Reference DA0594/2019

7 My Street Launceston. Proposal construction of two retaining walls.

**From:** agdarby  
**Sent:** 10 Dec 2019 09:35:58 +1100  
**To:** Contact Us  
**Cc:** Catherine Mainsbridge  
**Subject:** DA 0594/2019 - Proposed retaining walls at 7 My Street  
**Attachments:**

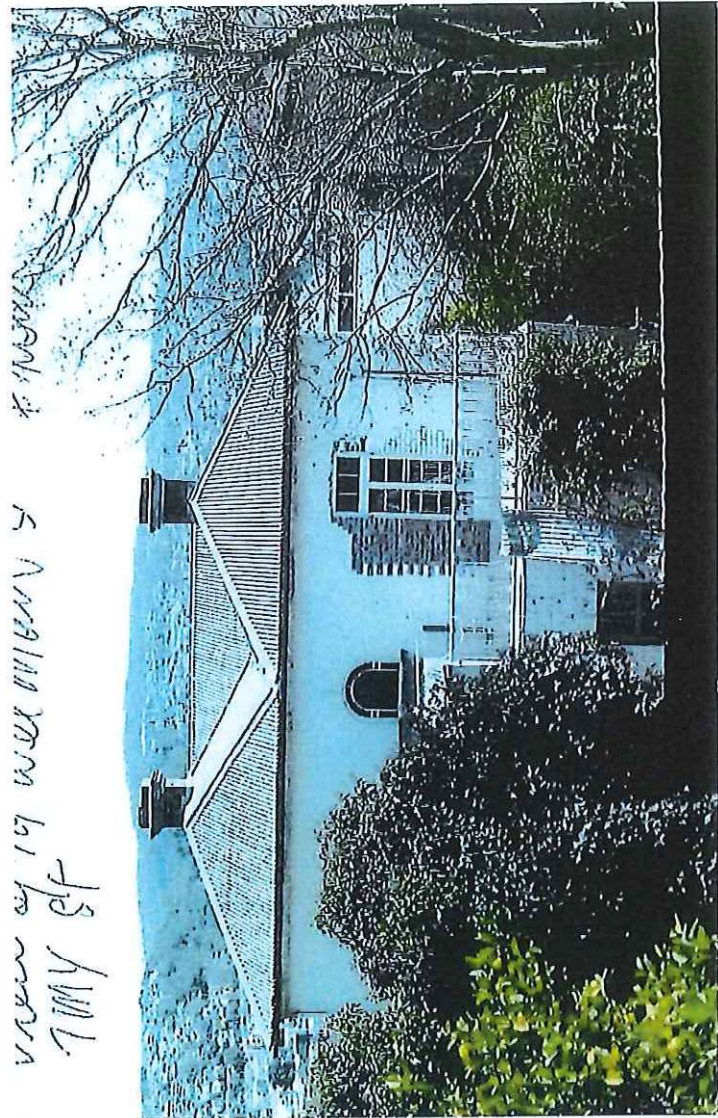
Top Blue stone wall, 1800 mm from ground  
Reinforced concrete wall on top 900 mm  
timber (?) fence on top of concrete wall 1500,  
Total 4200 mm privacy screen between  
7 M St & Welman St + vegetation on 7 M St

Boundary Fence Between 7MY St  
& Welman St  
in state of neglect & disrepair

Concrete wall  
leaning into [redacted] Welman Gf
